### Historic Landmarks Committee Hybrid In-Person & ZOOM Online Meeting Thursday, May 26, 2022 - 3:00 PM McMinnville Civic Hall: 200 NE 2nd St.

**DATE:** May 26, 2022  
**TO:** Historic Landmark Committee Members  
**From:** Adam Tate, Associate Planner  
**SUBJECT:** HL 5-21 (Certificate of Approval for Alteration) – 228 NE 3rd Street

**Figure 6 and 7: Plans of proposed door and awning**

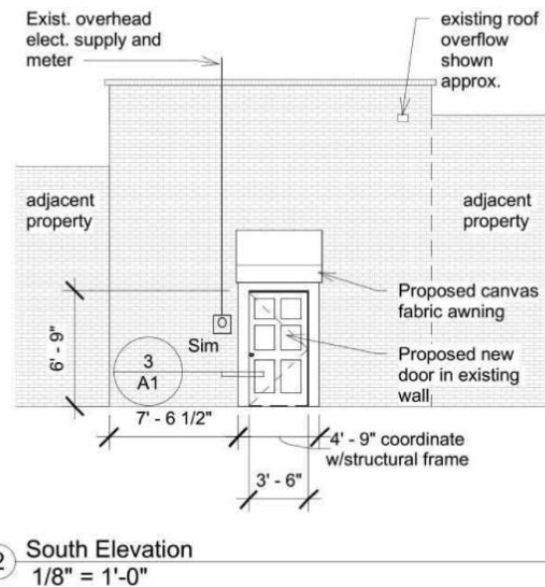
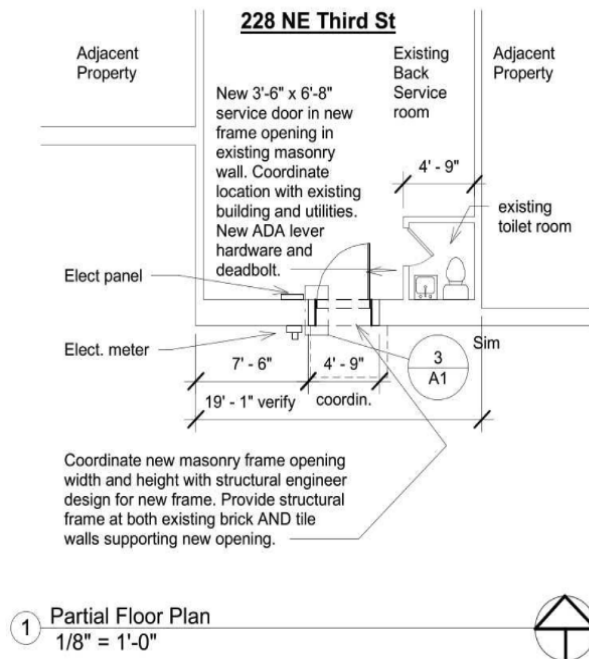
**APPLICANT'S RESPONSE:** The new service door and awning will be similar to the neighbor door and awnings, per attached photos. No other changes are proposed to the existing brick masonry wall. There will be no new windows in the new door. No new light fixtures are proposed.

**FINDING: SATISFIED WITH CONDITION OF APPROVAL #1.** That the applicant shall submit building permit applications prior to completing any work. The construction plans submitted with the building permit applications will be reviewed by the Planning Director for consistency with the written narrative, exhibits, drawings, and renderings submitted for review by the Historic Landmarks Committee, along with any revisions to respond to other conditions of approval

**Figure 4: Existing Exterior Conditions** **Figure 5: Example of a nearby door similar to one proposed.**

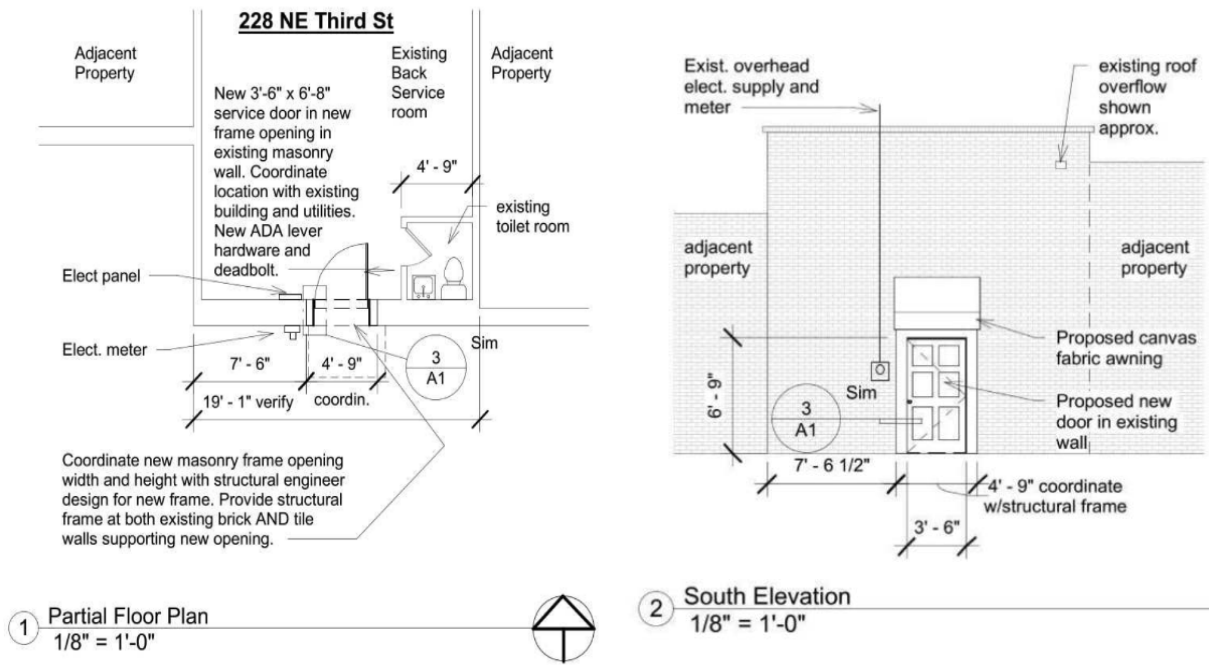
Existing south wall of existing building, shows some brick masonry damage typical of original south or west facing brick walls. Remove sign of past tenant. Relocate waste and recycle bins used by adjacent businesses and tenants.

Existing adjacent business added back door and awning, proposed new door and awning to be similar, except no glass, and metal faced door.
